LOCKHEED AIRCRAFT CORP.		ENGINEERING STUDY <input checked="" type="checkbox"/>		LAC - 69 *						
		CHANGE PROPOSAL <input checked="" type="checkbox"/>								
DATE 2-17-60		AFFECTS : WSPO <input type="checkbox"/>		PROJECT <input checked="" type="checkbox"/>						
NAME OF MAJOR COMPONENT FACE PIECE ASSEM.		PART OR LOWEST SUBASSEMBLY FLEX. HOSE ASSEM.		PART NO. & MODEL OR TYPE Q-237						
TITLE OF PROPOSAL : FACE PIECE HOSE AND ELECTRIC WIRING ASSEM. - REPLACEMENT										
NATURE OF PROPOSAL :  <u>SEE PAGE 2</u>  * THIS CHANGE PROPOSAL CANCELS AND REPLACES LAC-40 FOR CUSTOMER 1 ONLY. (LAC-40 NOW APPLIES TO CUSTOMER NO. 2 ONLY)										
REASON FOR PROPOSAL :  A hazard exists upon ejection if the emergency face heat wires are connected to the face piece. This could cause the pilot's head to be pulled downward until the emergency face heat wires break or pull away from the face piece. It is possible that, when the emergency face heat wires come loose from the face piece on ejection, the attaching studs may be loosened or withdrawn from the face piece causing an oxygen leak.

**NATURE OF PROPOSAL:**

## NEW HOSES FOR FACE PLATES (See Page 5 for Drawing)

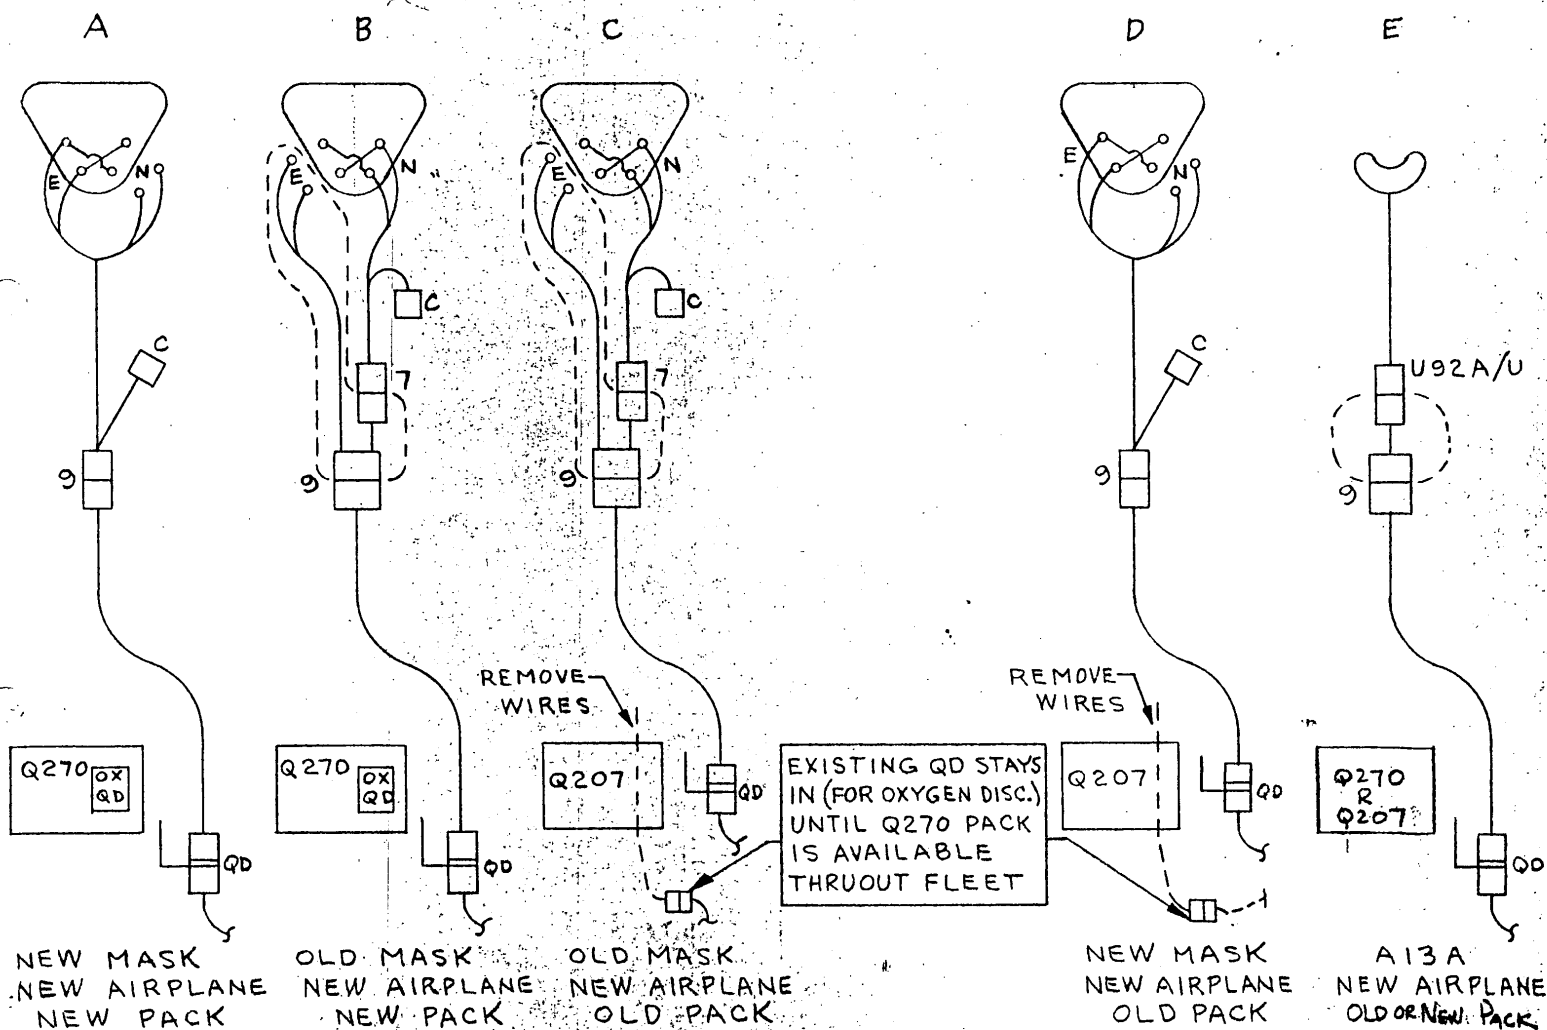
1. Provide a new face piece hose and wiring assembly which includes all required face piece wiring and has a single nine pin connector.
2. Provide a breakaway electrical connector on the side of the seat that will separate on ejection without putting a load on the face piece wires.
3. Revise aircraft circuitry to accommodate 1 and 2 above.
4. Remove all wiring to and within the Q-207 seat pack.
5. Provide wiring harness adapters that adapt the A13A mask to the system described above.

6. Provide a wiring adapter that will adapt the "old style" face piece wiring to an airplane that has had the circuitry and electrical disconnect installed.
7. Prepare and issue Service Bulletins and fabricate appropriate aircraft provisioning kits.

FIG. A & D      New Hose      \$51.95 ea.

FIG. B & C      New Hose      \$21.10 ea.

FIG. E      Connector (9 point)      1 Req. )  
Plug (Note for UL74/U)      1 Req. )      Approx. \$20.00  
Wiring      -      )
